BEFORE THE WHANGAREI DISTRICT COUNCIL AND NORTHLAND REGIONAL COUNCIL

IN THE MATTER of a resource consent application by Northport Limited under section 88 of the Resource Management Act 1991 for a port expansion project at Marsden Point

STATEMENT OF EVIDENCE OF CRAIG JONATHAN DAVIS

8 SEPTEMBER 2023

Figure1 -Hjulstorm Curve (Showing currents can erode and transport Roost)

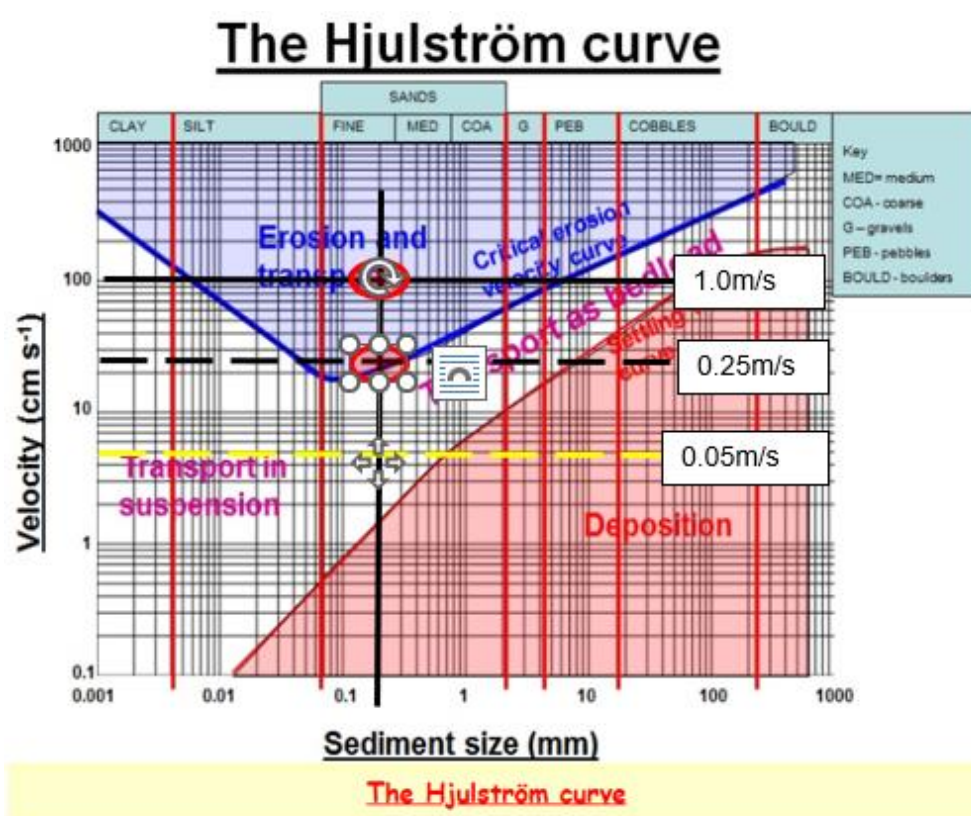
26. The CPA notes tidal currents of 1m/s at Marsden Point and, from Figure 3.11 B, these appear to be about 0.2m/s in the relevant location. Mr Reinen-Hamill asserts in his evidence (Para74) that the currents are 0.05-0.25 m/s. The Hjulstrom curve (Figure 1) is a basic tool for assessing sediment transport and shows that the 0.05m/s current is sufficient to transport Sand such as found east of the Port (D_{50} of 0.2mm). Current speeds as low as 0.25 m/s are sufficient to actively erode it.
